Independent Review of Tillegra Dam Hydrology

as described in the Environmental Assessment Report, August 2009,
and the Environmental Assessment Submissions Report, March 2010

Final Report

27 September 2010

Figure 2: Mass Balance Diagram

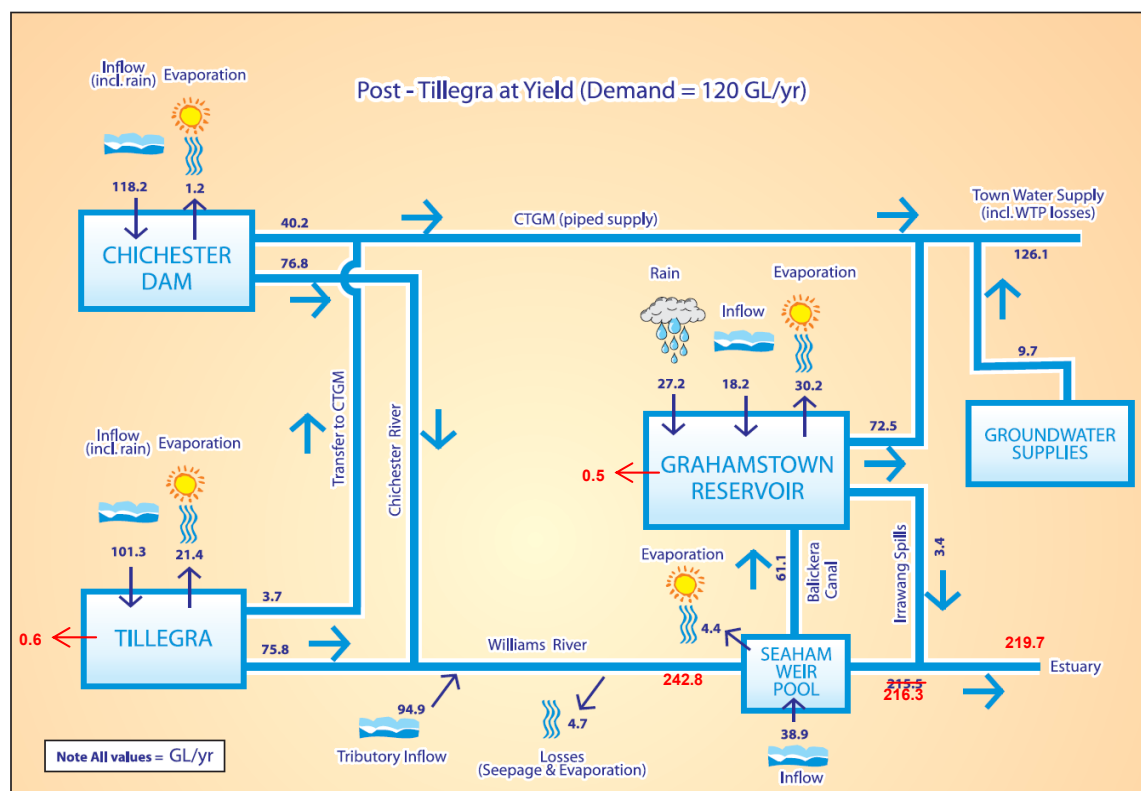
In relation to the mass balance information provided on Figure 10.7:

- (a) the source of the average annual values provided on Figure 10.7 is not immediately apparent. The 'post-Tillegra' numbers do not correspond exactly to any of the *SoMo* data sets described in the *SoMo Report*. Nevertheless, the differences are minor and would be unlikely to alter any of the conclusions one draws from this figure. It is apparent that the model has been operated and refined on occasions during the preparation of the EAR and the EASR, and as a number of different data sets have been provided to the consultants documenting the EAR and EASR, it may be difficult to identify the true origin of all the information used;

- (b) the mass balance in all parts of the system illustrated in Figure 10.7 is not necessarily preserved. Imbalances occur in a few locations and HWC have clarified¹⁵ these in response to questions asked by the reviewer. In particular:

- (i) there is an imbalance at Grahamstown Dam for 'pre-Tillegra' and 'post-Tillegra' conditions. In both cases, this is due to a change in storage in the Dam which was not reported in Figure 10.7. These amendments have now been made in 'red' and are shown on **Figure 2**.

- (ii) a similar mass-balance error occurs with Tillegra Dam on Figure 10.7 and this has also been corrected in 'red' on **Figure 2**;
 - (iii) discussions with HWC have indicated that *SoMo* assumes approximately 10% of water specifically released from Tillegra for transfer to Grahamstown Dam is assumed to be inaccessible to the Balickera Pumps due to unforeseen operational constraints which may occur. On the advice of HWC, this additional loss stream is assumed to pass through the Seaham Weir pool and into the estuary. Accordingly, modifications to this part of the diagram have also been included in 'red' on **Figure 2**;

- (iv) in addition, spills from Grahamstown Dam find their way into the estuary and have been included in 'red' on **Figure 2**.
- (c) note that the modifications made in 'red' on **Figure 2** seek to resolve inconsistencies in Figure 10.7 of the EAR based on the *SoMo* results. Further corrections could be made to these results themselves (e.g. to improve the prediction of local catchment inflows to Glen Martin and Seaham Weir), but these have not been attempted by the reviewer.

(This is a reprint of Figure 10.7 from Volume 1 of the EAR. Additions in 'red' have been made by the reviewer. Note that the local catchment inflows at Glen Martin and Seaham Weir are based on the SoMo results and the reviewer has not attempted to rectify the identified deficiencies in the simulation of these inflows. For example, the 270.9GL/yr inflow to Seaham Weir, pre-Tillegra, should probably be around 320GL/yr).
